# SR 520 Portage Bay Bridge & Roanoke Lid

## Project Description

**June 6, 2019**

Briefing

Figure 2: Elements of continuity (top) and elements of distinction (bottom)

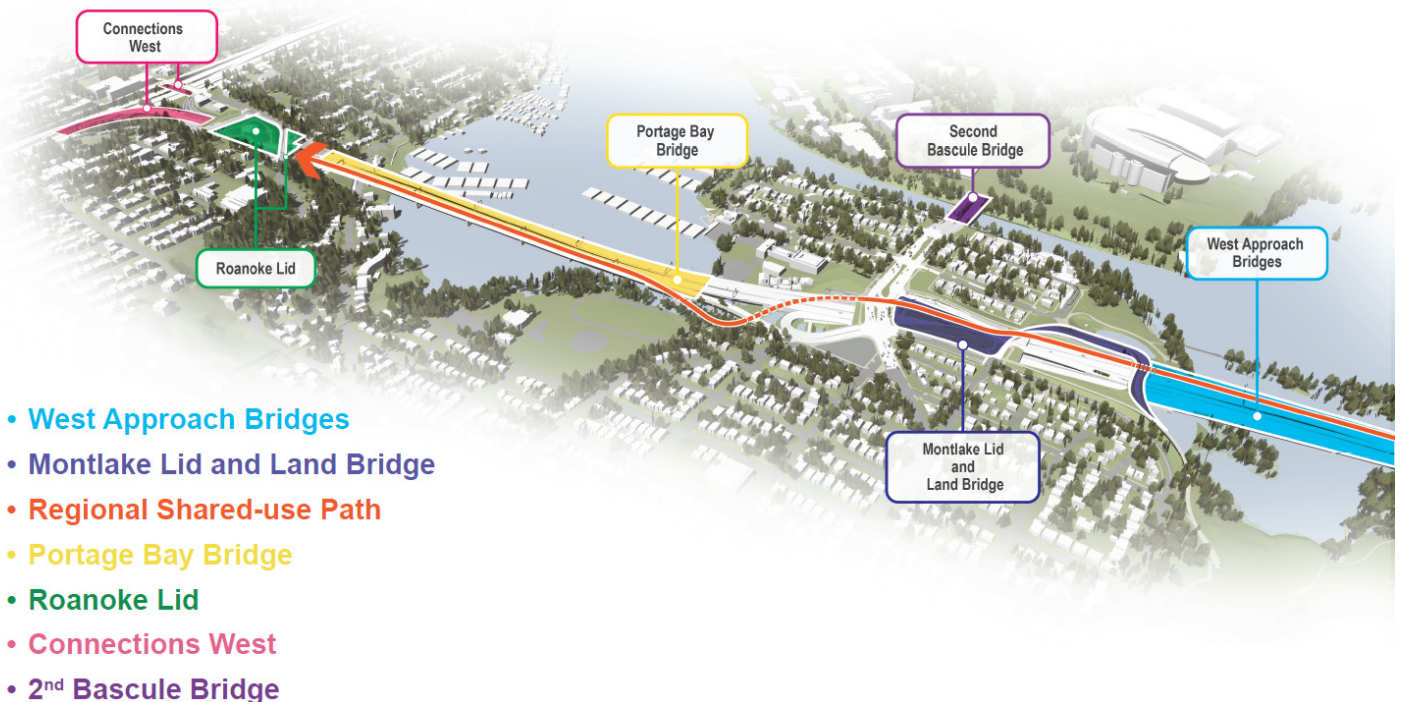
The SDC commended the project team for the initial Portage Bay Bridge design concept. Specifically, commissioners appreciated the proposed height of the bridge, which will provide an improvement for the

trails and pathways located below. The Commission highlighted several opportunities that can be achieved through the replacement of the Portage Bay Bridge. The SDC recommended the team continue to consider the elegance and lightness of the bridge as the design continues to develop. The SDC then discussed how the bridge will be seen and experienced from varying distances and locations. The commission encouraged the project team to consider the design of the bridge, as well as the user experience, from different locations near, on, and below the bridge. Commissioners were especially interested in understanding how users will interact and experience specific elements such as the columns as well as understanding how people will experience the bridge from the water below. Several commissioners recommended the team explore ecological opportunities in the design of the portion of the bridge columns that are submerged beneath the water. The SDC then expressed concern with the amount of signage on the bridge deck and its relationship to the overall design on the bridge deck. Commissioners recommended the project team consider the amount of signage that is actually needed and then to provide renderings that are reflective of the amount of signage proposed.

The SDC expressed concern with the proposed design of the RSUP where it connects to the Roanoke lid. Commissioners recommended the project team consider avoiding switchbacks and encouraged the team to consider an alternative solution or alternative location for the RSUP to connect from the bridge that is more intuitive for users.

1. Increase the lightness and elegance of the bridge.
2. Consider the experience of the bridge from the water.
3. In addition to considering the pedestrian interaction with sculpted concrete work, consider the experience from the water.
4. Explore adding ecological value with the sculpting of the columns in the water.
5. Consider the views of the columns not just from far away but also from closer, such as 10 ft away.
6. Be realistic when rendering and considering the amount of signage that will be needed for the project.
7. Avoid switchbacks and explore peeling the RSUP off of the mainline of the bridge where it will result in an elegant solution.
